ALEXANDRIA LANDFILL

**Submission
on behalf of
Alexandria Landfill Facility**

**PROPOSED DEVELOPMENT – ST PETERS
MATERIALS RECYCLING FACILITY PROJECT
(MP_0086)**

Figure 3 Annual and Seasonal Wind Roses for Sydney Airport

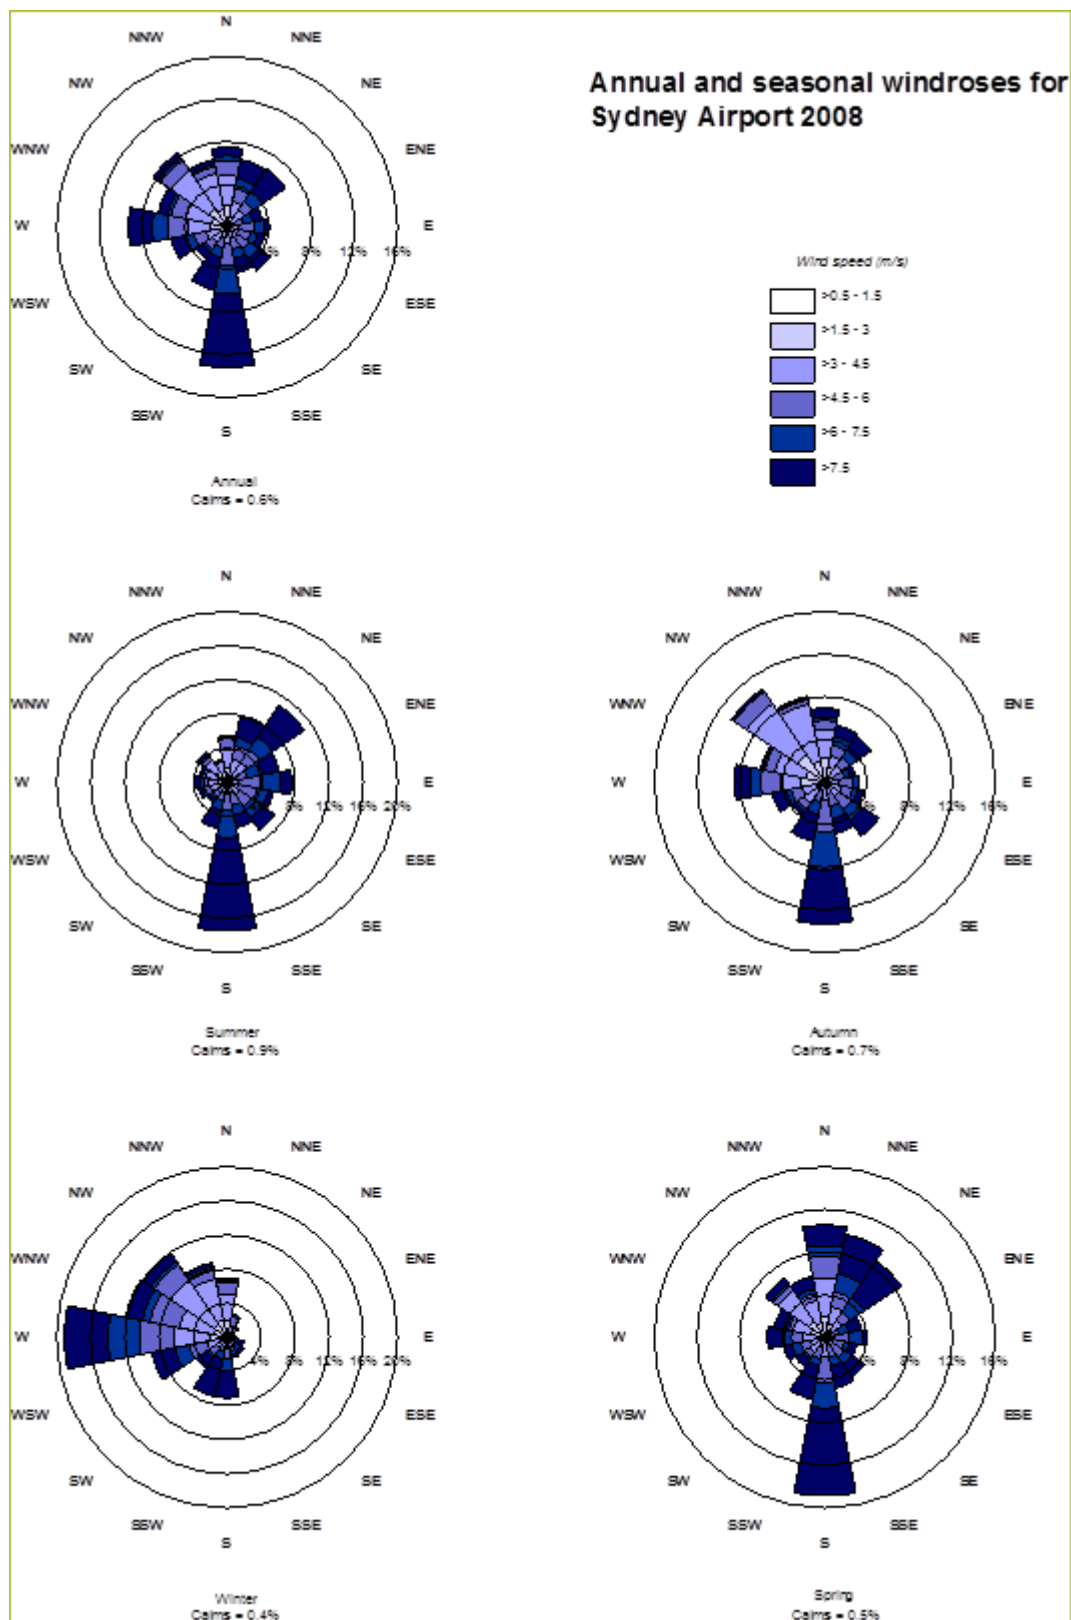
These windroses indicate that the 8 (can you believe it?) residential homes only 15 metres from the northern boundary of the site would be those likely to be affected.

The rear gardens of those homes are only a 4 metre lane width away from the Project area.

Figure 4.1: Dust Deposition Monitoring Results

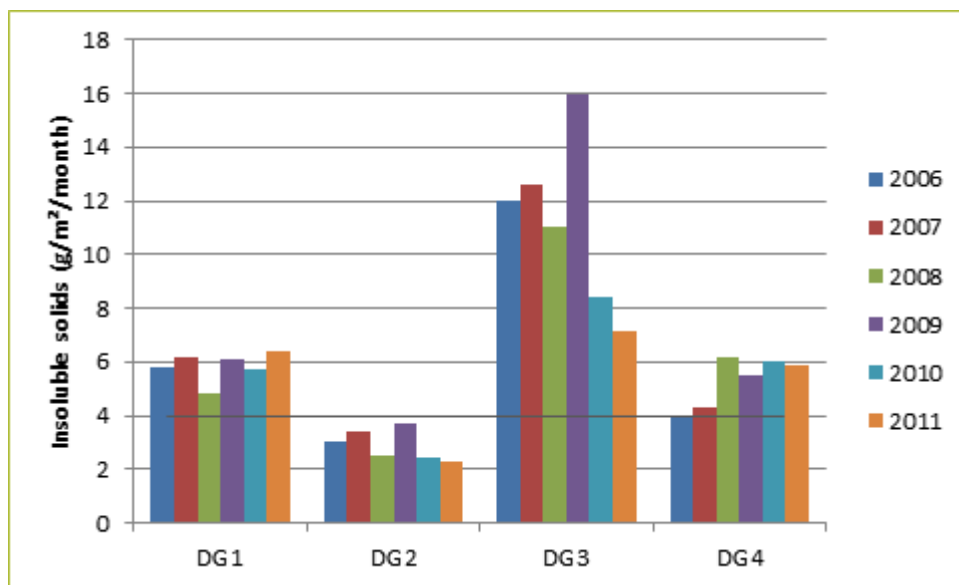
MODELLING RESULTS IN THIS CASE ARE FOR THE PROJECT ALONE AND ARE NOT PRESENTED AS AN INCREMENTAL INCREASE IN DUST DEPOSITION RATES SET AGAINST EXISTING AIR QUALITY STANDARDS
